BUILDING SURVEYOR'S REPORT.

PLAN FOR PROPOSED FISH-MANURE FACTORY
ON MANGHA-PIR ROAD
SCALE 1/2"=1'

**MUNICIPAL CORPORATION,
KARACHI.**

Reference No. B. S. P. 346/34

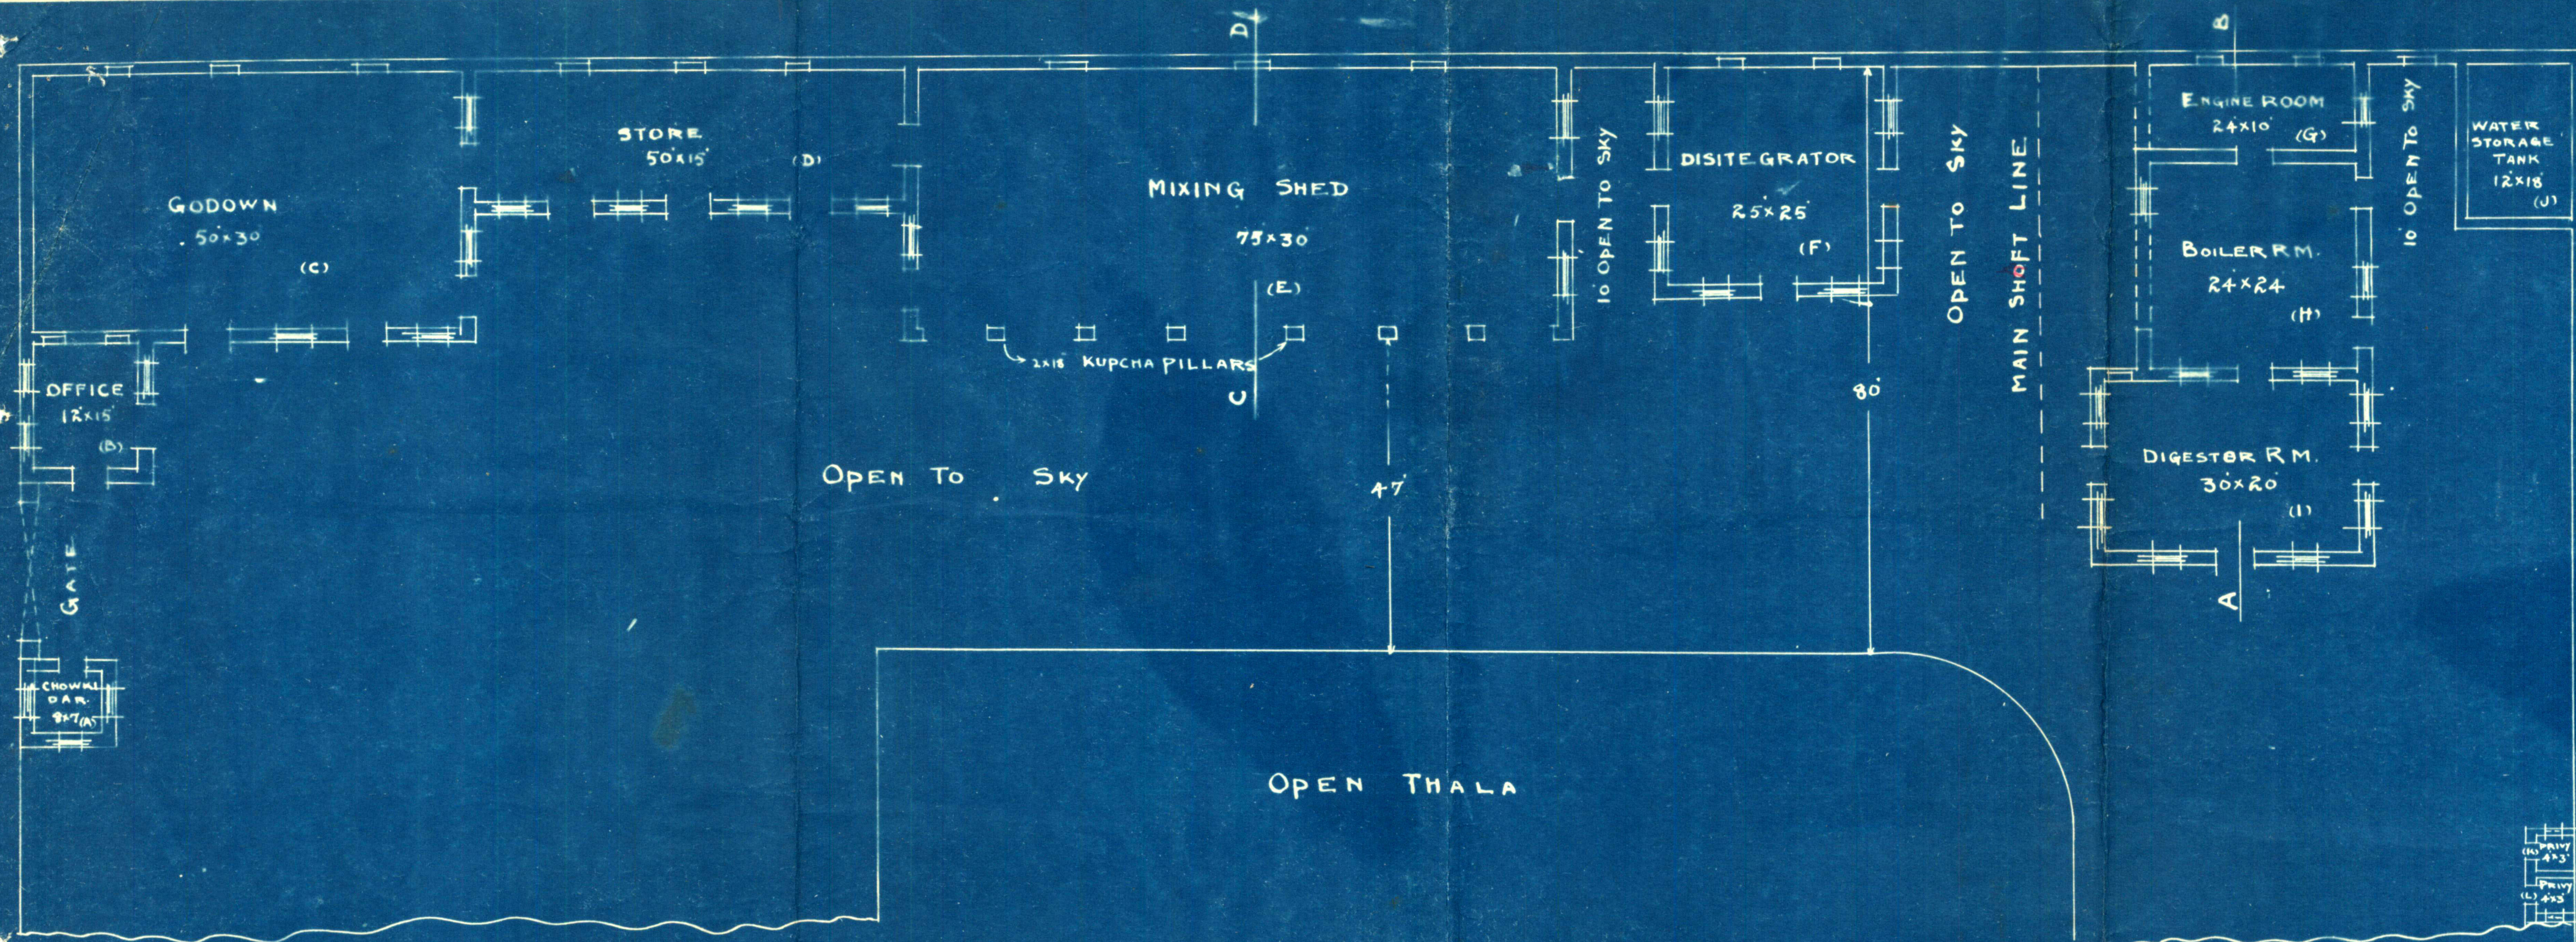
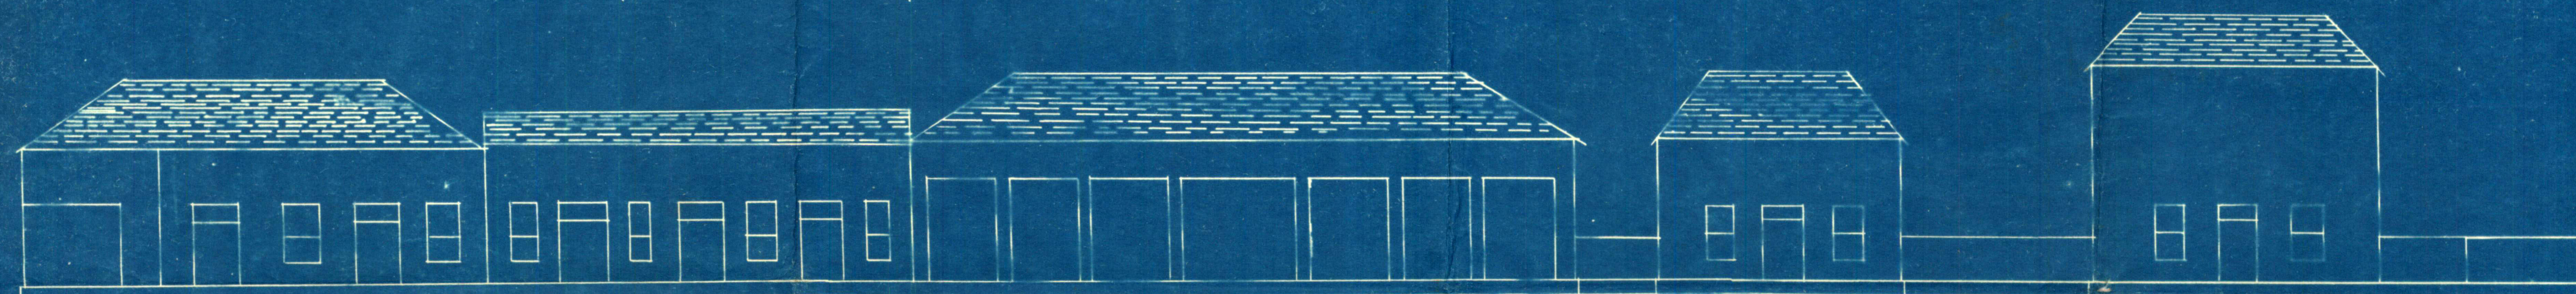
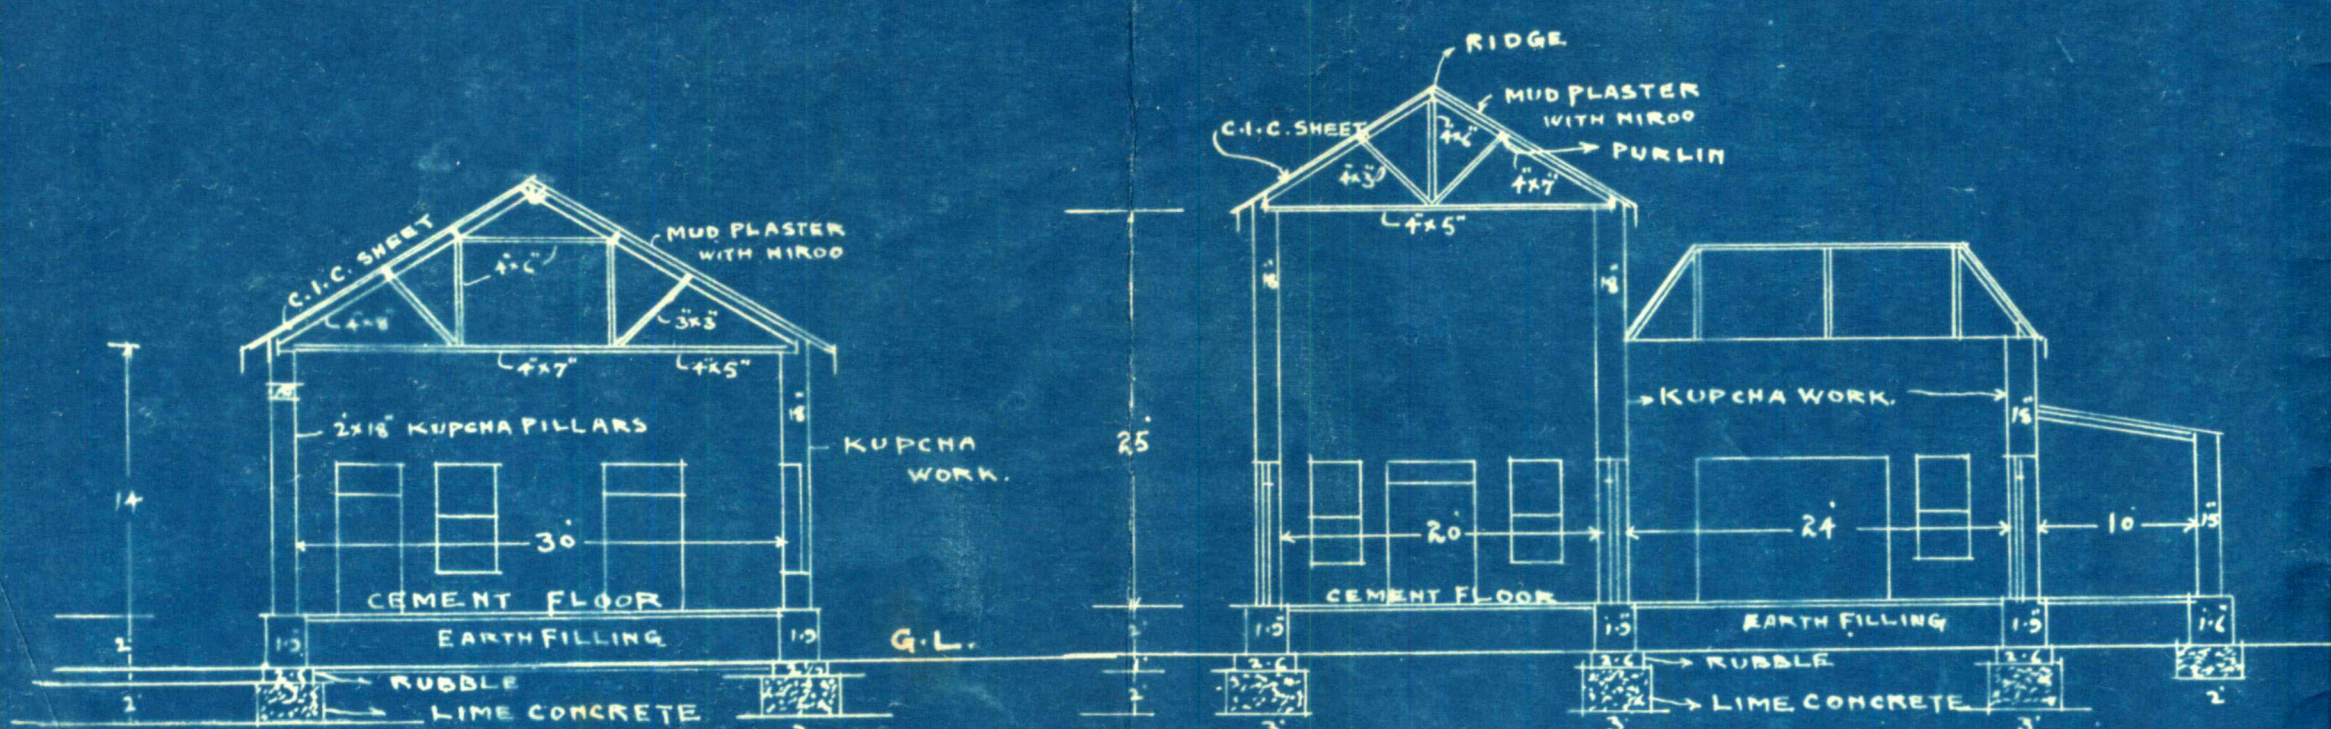
- ① Chokidar's room cannot be allowed less than 80' Sq. ft.
- ② Roof details for the various rooms must be shown clearly on plans.

- ✓ 1. Chokidar's room cannot be allowed less than 80 sq. ft.
- ✓ 2. Roof details for the various rooms must be shown
clearly on plans.

objections have been complied with
Man approved 24/7 *31/7*
